Total Maximum Daily Load for Lower Snake River Total Dissolved Gas

Publication No. 03-03-020

Washington State Department of Ecology

Appendix: Response to Public Comments

Figure 10. Observed and Estimated TDG Pressure in the Forebay of Lower Granite and Little Goose Dams, June 1997 (No Entrainment of Powerhouse Releases).

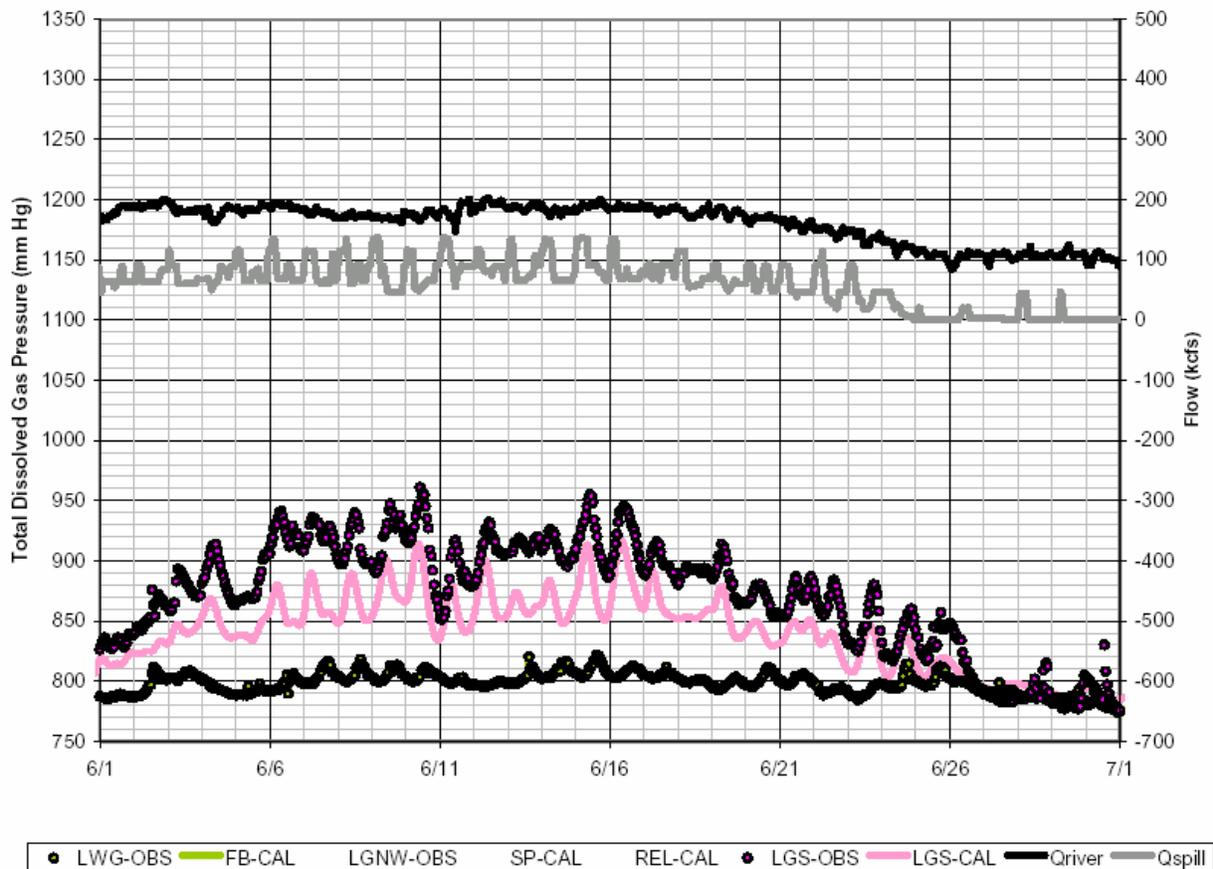
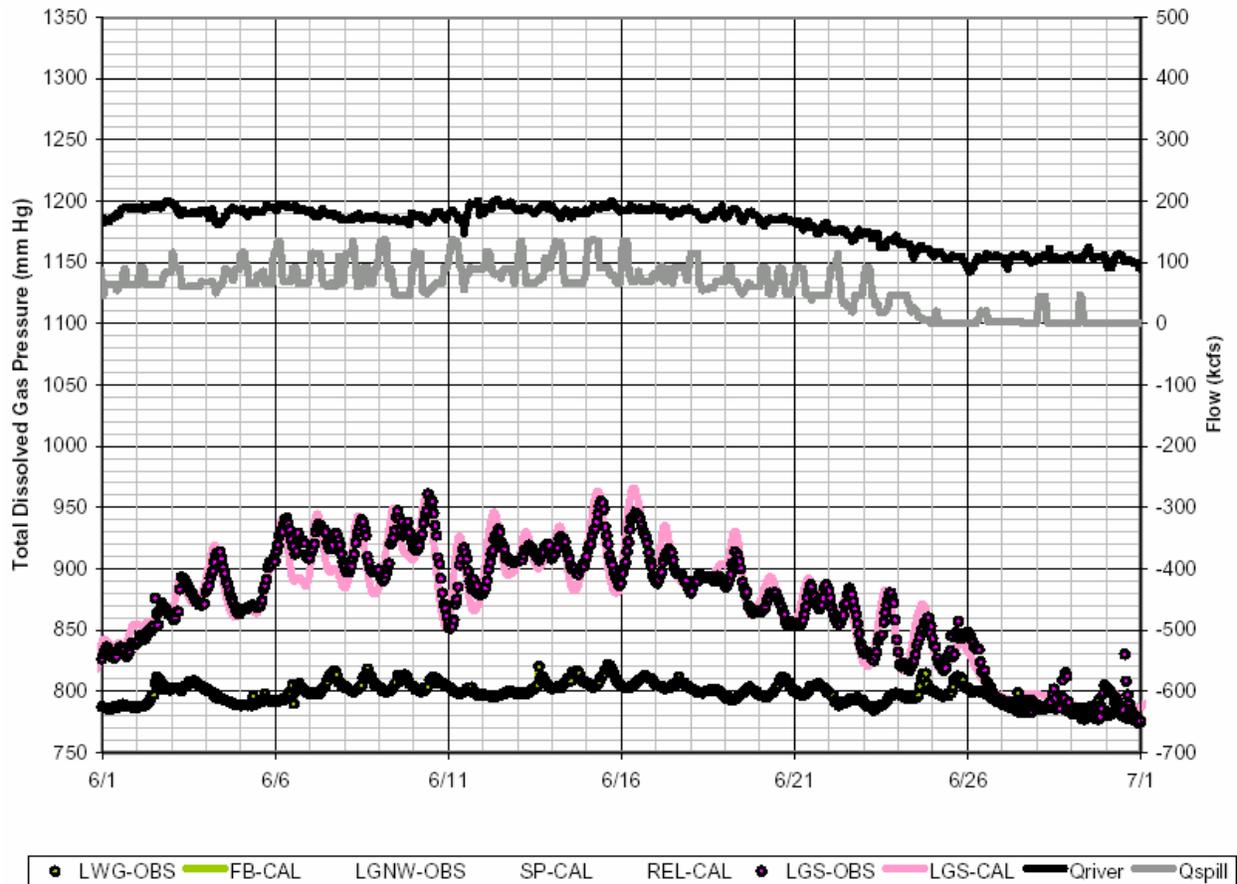
Comment: Pages 33&34: Figures 10 and 11 appear to be the same, seems redundant to have them twice in two pages.

Figure 25. Key Features of Potential Tailwater Compliance Area Boundaries.

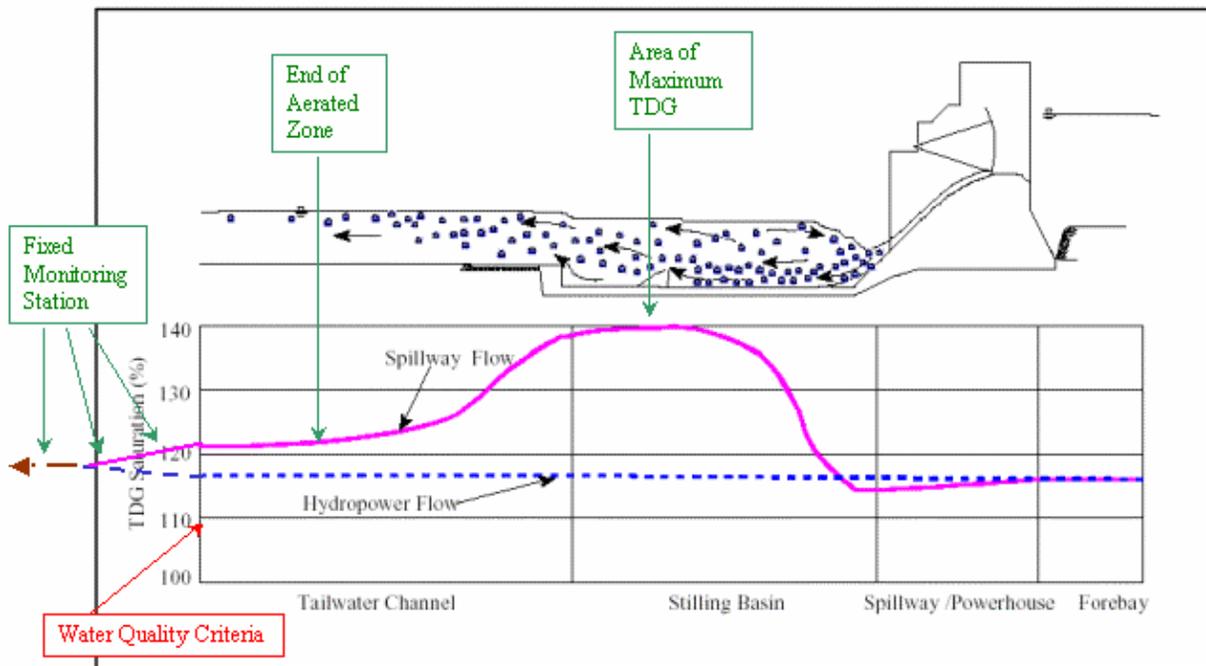
Comment: Page 60 – Figure 27 – This figure is misleading. The change in TDG pressures between the end of the aerated zone and existing fixed monitoring stations is often next to nothing, especially for the Snake River projects.

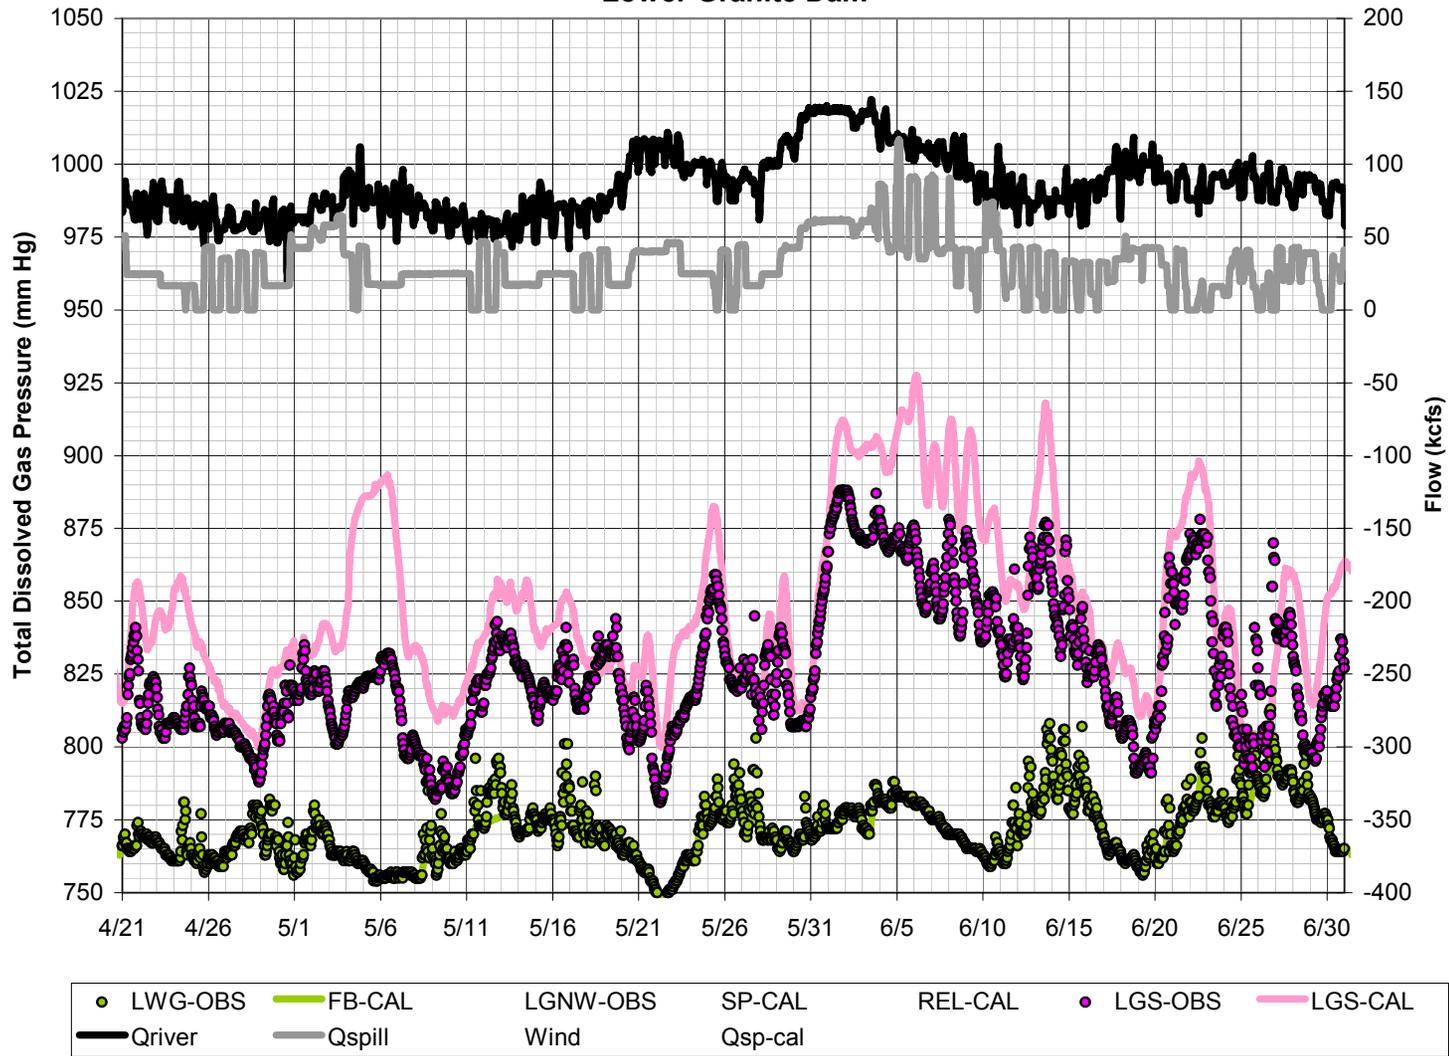
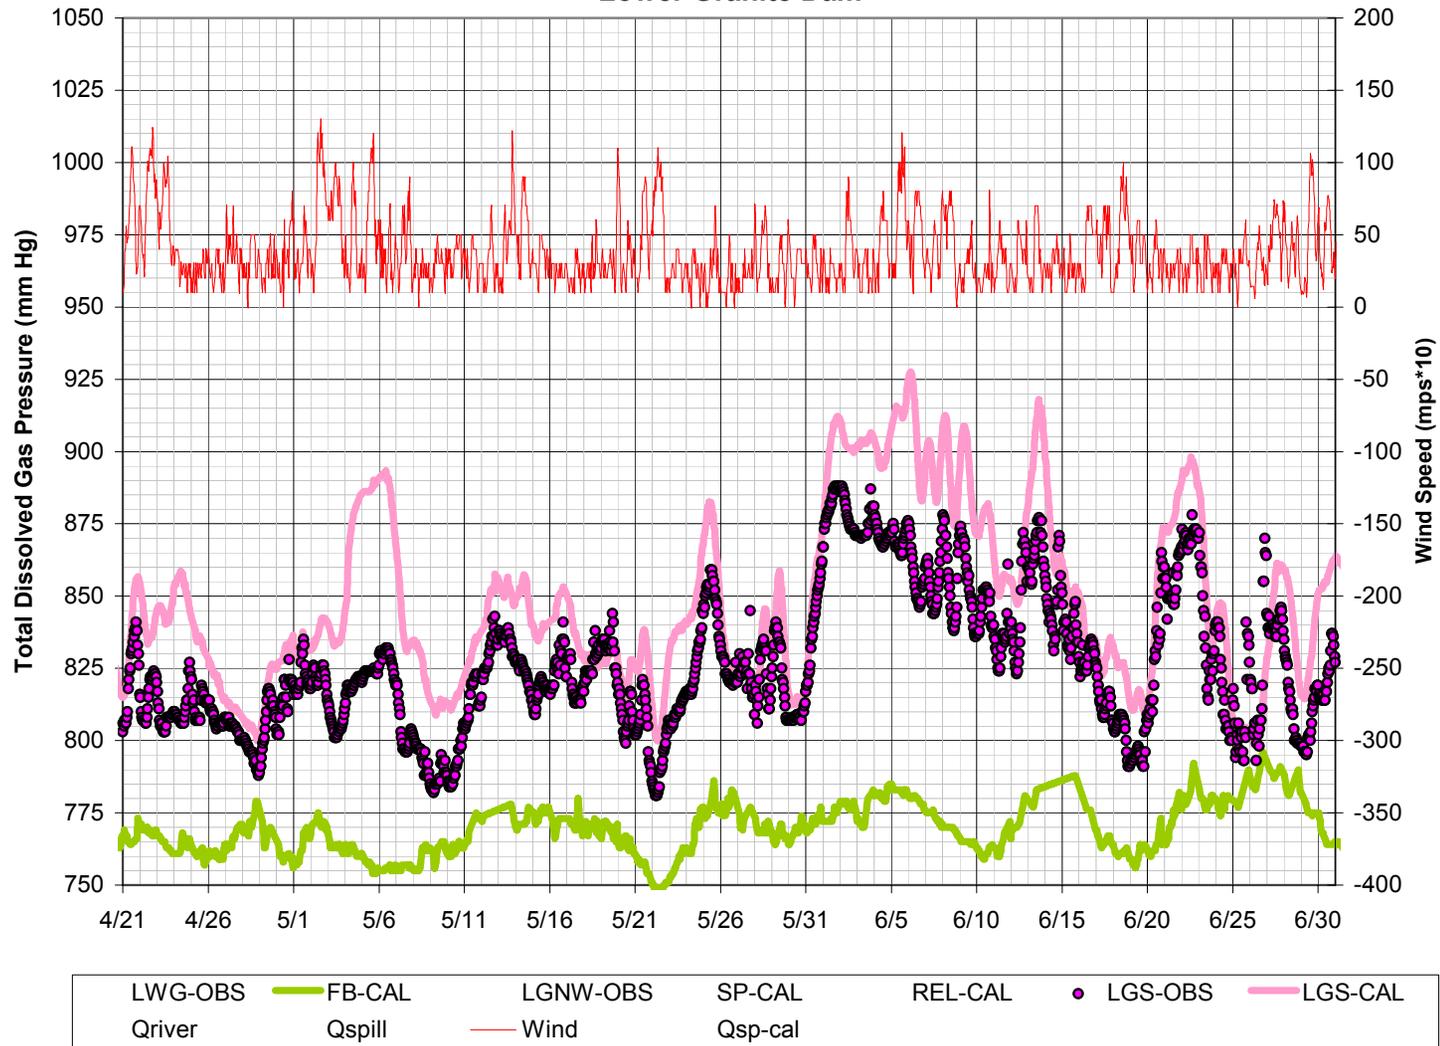
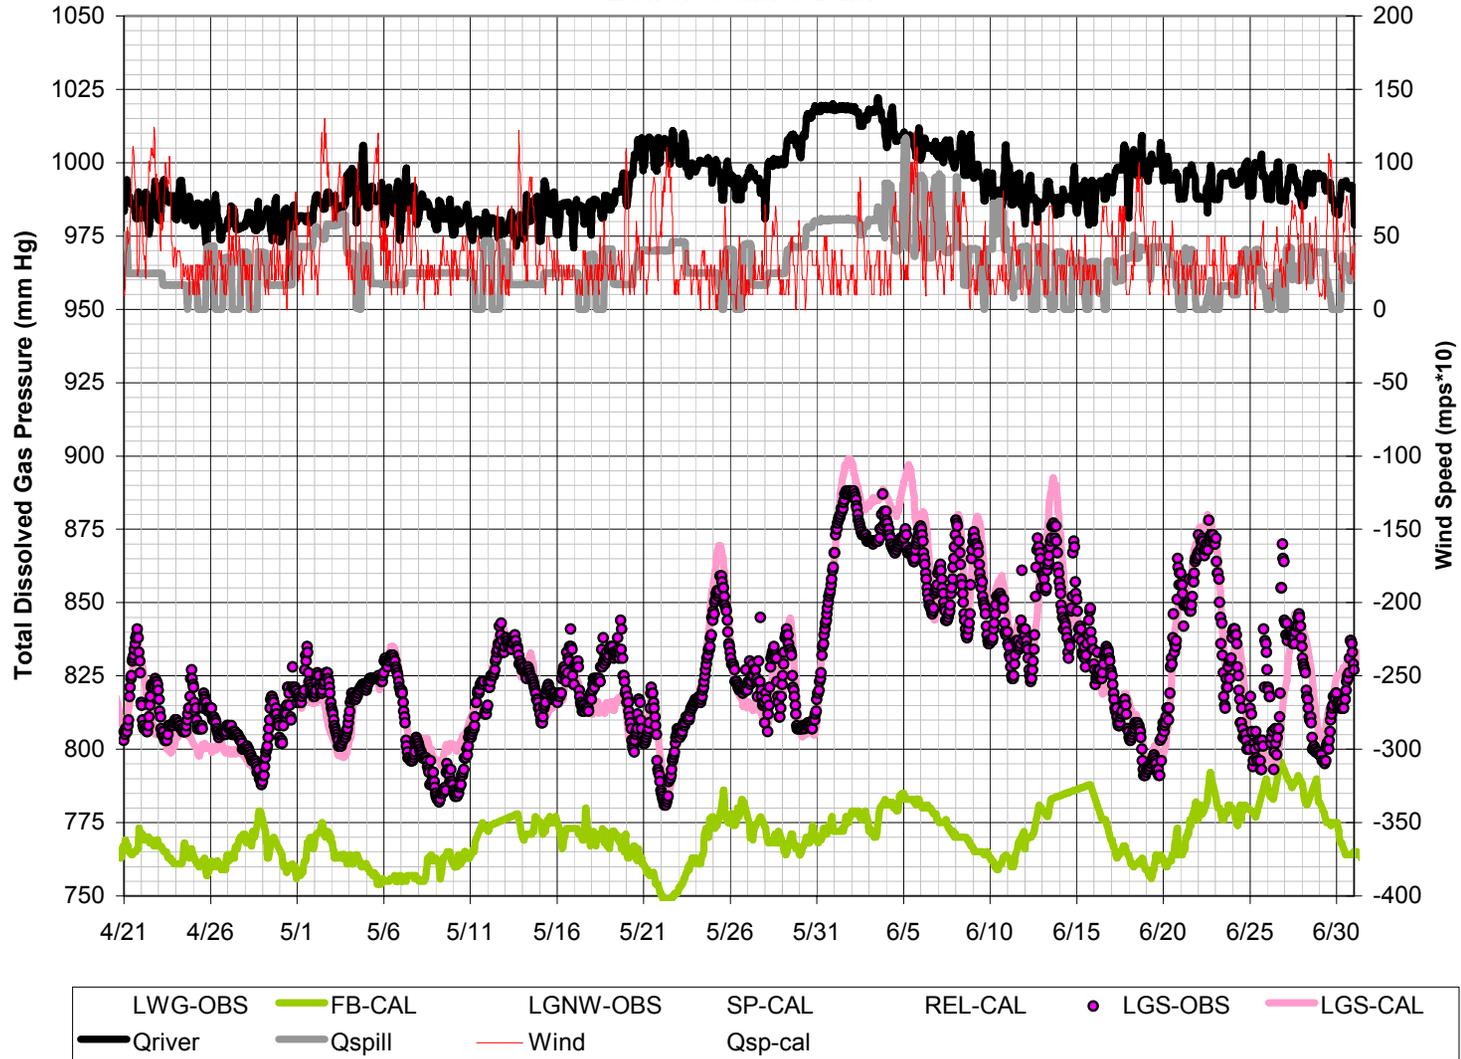
Comment: The load allocation for spill is overly protective of the water quality standard of 110 percent because the degassing component in the Snake River has been assumed to be negligent while applying a thermally induced pressure increase. A detailed accounting of TDG pressures in Little Goose pool during the 2002 fish passage season was used to calculate the loss rate of TDG pressure in this river reach.

An array of TDG instruments were deployed below Lower Granite Dam during the 2002 spill season. These data were used to quantify the TDG loading produced during spillway flows at Lower Granite Dam. These TDG pressures were routed through the Little Goose pool by using the SYSTDG workbook to evaluate the exchange rates of TDG pressures. The observed (symbols) and calculated TDG pressures (pink line) assuming no loss of mass in transit through the Little Goose pool is shown in Figure 1. The conservative transport of TDG pressures in the Little Goose pool resulted in forebay TDG pressures at Little Goose Dam much larger than observed at the forebay fixed monitoring station. The routed pressures reflect the change in temperatures observed between these projects but for a constant concentration as discharged from Lower Granite Dam. The calculated TDG pressures with no degassing were greater than the observed conditions throughout the fish passage season and exceeded the observed conditions by as much as 60 mm Hg. The hourly wind speed (mps * 10) as observed at the Agrimet station located at Rice Bar on Lake Bryan is shown along with the observed and calculated TDG pressures in Figure 2. The circled periods of high wind shown in Figure 2 correspond with large differences between the observed and calculated (no degassing scenario) TDG pressures in the forebay of Little Goose Dam. The high wind events also correspond with decreasing TDG pressure in the forebay of Lower Granite Dam (green line).

The seasonal simulation of TDG pressure in Lake Bryan was repeated assuming TDG pressure is continuously exchanged at the water surface of the Snake River. The mass exchange was assumed to be a first order process driven by the gradient between the local TDG pressure and the atmospheric pressure. The exchange coefficient was assumed to be a function of the wind speed. The observed and calculated TDG pressure in the forebay of Little Goose Dam assuming degassing at the water surface is shown in Figure 3. The observed and calculated TDG pressure is similar throughout the fish passage season with an average predictive error of -2.5 mm Hg and an rms error of 10.4 mm Hg. The statistical summary of the change in TDG pressure between Lower Granite and Little Goose Dams with and without in-pool degassing is shown in Table 1. The average change in hourly TDG pressure released from Lower Granite Dam to the forebay of Little Goose Dam was 19.4 mm Hg or about 2.6 percent saturation. The loss of TDG pressure was greater than 43.7 mm Hg during 5 percent of the hourly releases from Lower Granite Dam. The loss of TDG pressures was less than 7.2 mm Hg 5 percent of the time. The degassing of TDG pressures in the Snake River was significant during the 2002 spill season. The loss of TDG pressure during transport is a continuous process that occurs with or without strong surface winds. The presence of strong sustained winds can greatly accelerate the exchange of gasses between the Snake River and the atmosphere. In most cases, degassing at the water surface is considerable larger than thermally induced pressure gains. The frequency of moderate to high winds (5 to 10) relative to the time of travel through the pool (typically 2 to 4 days) supports the claim that ignoring the degassing processes in determining the load allocation for TDG in the Snake River will result in an overly restrictive criteria.
